APPLICATION			REVISIONS			
PART NO.	NEXT ASSY	USED ON	REV	DESCRIPTION	DATE	APPROVED
		IN0112A	-	INITIAL RELEASE	03/03/04	W. ANDERSON
				AS ROW Redline

DWG NO. 564419 SH 1 REV -

**High Resolution Instrument (HRI)
Performance Test Procedure**

Figure 8-2 Integrating Sphere Mechanical Setup

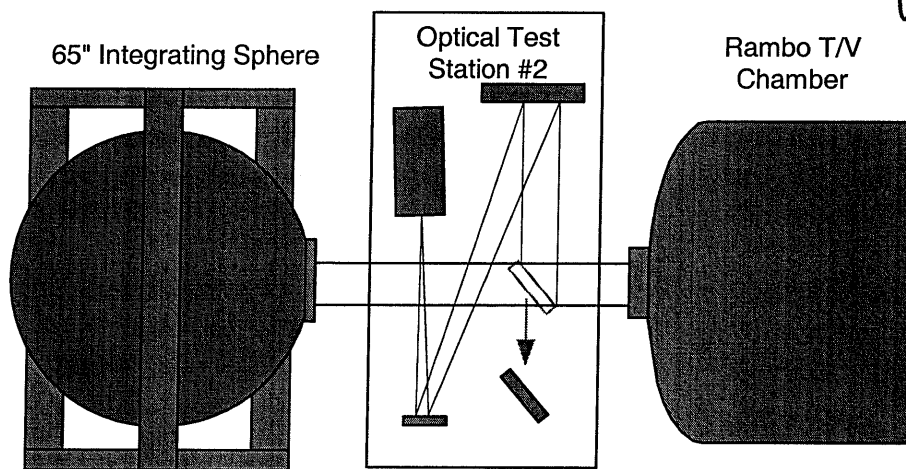
Use theodolite sight to center on telescope boresight, then rotate 180° & measure center on sphere
DLH 3/5/03
CBS 4/25/03

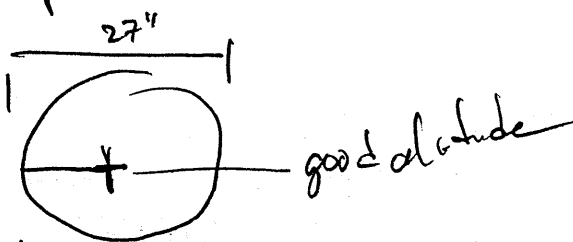
Used theodolite sight to align along HR1 Bobesight, rotate 180
sight
sight on sphere.
liffid tent on to
ground behind aperture.
